SYSTEM CHANGE | S60 Multi-Link System

UPDATED SYSTEM		CHANGES MADE	
DESCRIPTION.		YES	NO
DESCRIPTION.	S60 Multi-Link System	<input type="checkbox"/>	<input checked="" type="checkbox"/>
IMAGE.	 <div> 1. Idler End Bracket 2. Idler 3. Intermediate Receiver 4. Intermediate Bracket 5. Intermediate Drive </div>	<input checked="" type="checkbox"/>	<input type="checkbox"/>
PRODUCT OPTIONS.	Single, Adjustable Bracket Non-Adjustable Bracket, 60mm 80mm	<input type="checkbox"/>	<input checked="" type="checkbox"/>
TRANSITIONING.	01 SEP 2018

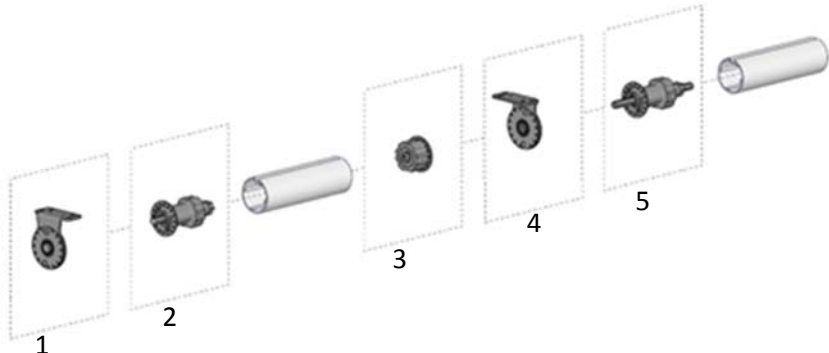
- Noise reduction from material change:
 - A) Bushing change from hard plastic to softer plastic
- Noise reduction from design change:
 - A) Updated drive bushing shoulder reduces knocking effect due to geometry of parts
 - B) Receiver component changed to have a tapered end to reduce play between parts
 - C) Idler End bushing changed from a hex to a tapered cylinder to fit with new rounded Idler End shaft
